Environmental Impact Assessment

Screening according to Schedule III of S.L. 549.46

ERA Reference no.:	EA/00037/20
PA Reference no.:	PA/09046/18
Project Title:	To demolish existing restaurant, wine/ spirit bar and nightclub to construct basement garage and a mixed use complex including a Class 3A guesthouse, Class 4D restaurants, Class 5A crafts business and a Class 3C space for events, spread over four floors.
Location:	Wilderness, Triq I-Gharb, Ghasri, Gozo
Screening date:	October 2020

Figure 2: Proposed Section B-B (Source: E- apps doc PA9046/18/133g)

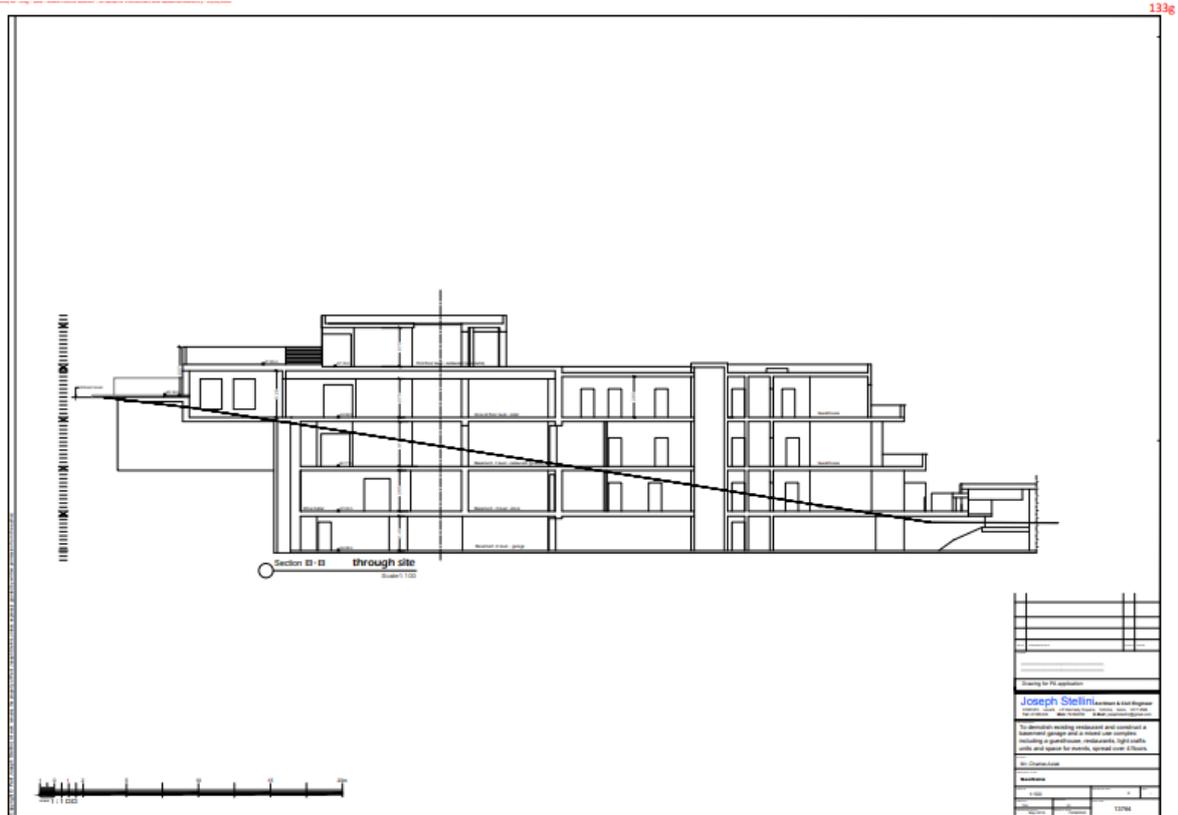
- 6.2 The main concern is that the proposal would result in a massive development that would be even more dominant and incongruous in the landscape than the existing structure. The current proposal fails to follow the terraced topography of the surrounding environment. Instead, it seeks to introduce an excessive number of floors through extensive excavation works to accommodate multiple basement levels that overlook the lower-lying valley bed at the rear of the site. The adverse visual and landscape impact of the proposal are considered significant, particularly at the rear of the site, facing the valley. The scale of the excavation works is also of significant concern.

- 6.3 Furthermore, in order to accommodate the envisaged scale of development, the proposal would also require encroachment onto the currently undeveloped arable part of the site, raising additional concern about further land uptake Outside Development Zone.

- the development should follow the topography of the surrounding environment, and its design and massing should blend more effectively into the landscape;
- the currently proposed excavations should be avoided;
- the massing should be reduced, and the overall profile of the building should be significantly mellowed through reduction of the number of floors. Particular attention should be paid to the rear and side profiles of the building, overlooking the valley.
- The 'depth' of the building and its encroachment toward the valley at the rear of the site should be curtailed.
